Primary School, Crown Street C3, Manchester

SAMPLE REVIEW SUMMARY | 26 September 2022
10329-C3-SHP-A180-Rp-XX-001 | REVISION P 01

Sample panel review

Part Elevation of School. Approved drawing ref C3-AKL-G251-SE-XX-0017 X01

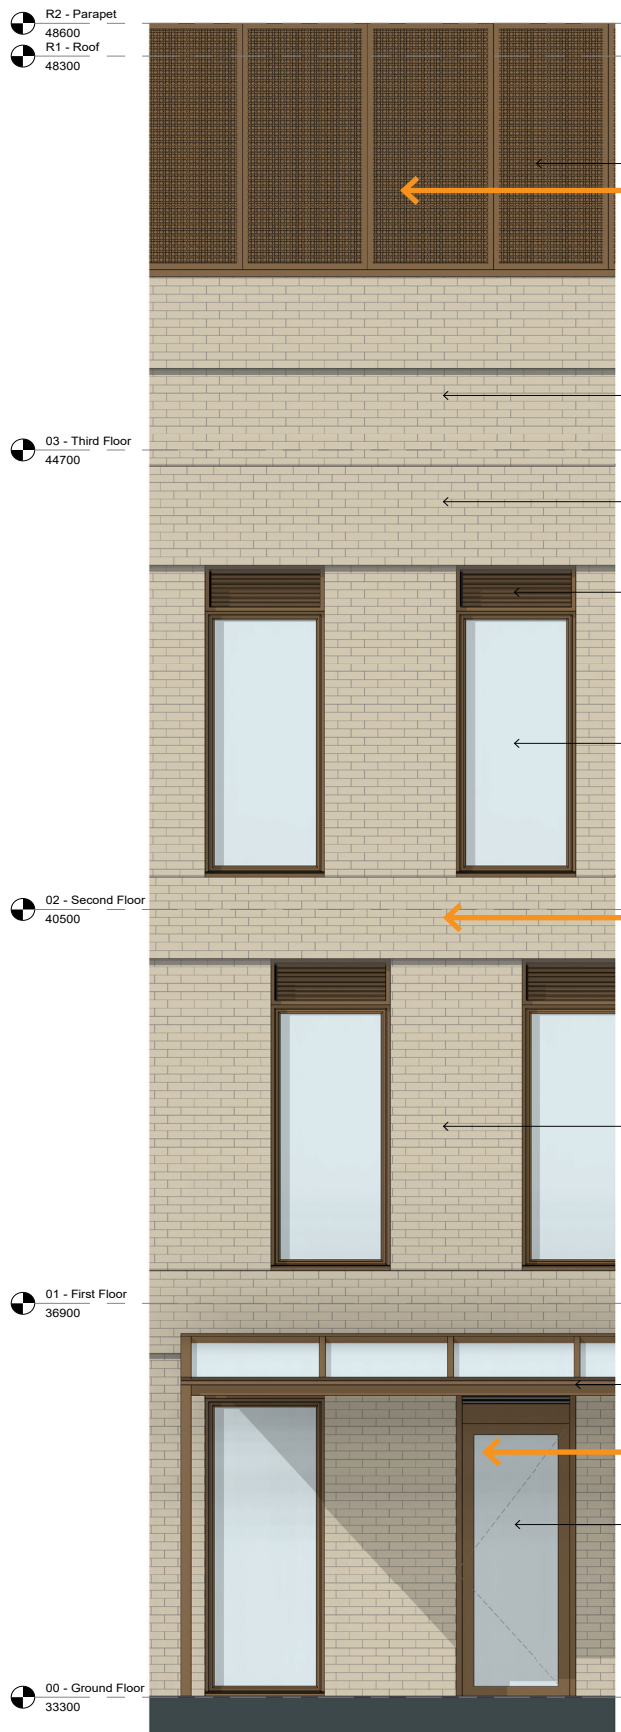
The brickwork has been built in stretcher bond using TBS Mystique brick and a coloured mortar, Tarmac Y111 “Maize”, which we have selected to match the brick. A buff sealant is used in the movement joint.

A number of sample panels had been constructed of the radiused brick corners to review the appropriateness of various brick bonds. The sample built using 2/3 bricks in stretcher bond for the radiused corner was agreed on the basis that this provided the smoothest curve and maintained the most appropriate relationship to the full stretcher bond used on the straight sections of brickwork.

The window and perforated panel samples were presented in bronze effect Tiger Dry Lac reference Tiger 68/60307 C33 Medium Bronze Anodised effect. These were agreed as acceptable. It was noted that the perforation pattern is still subject to review.

All of the above was agreed as acceptable.
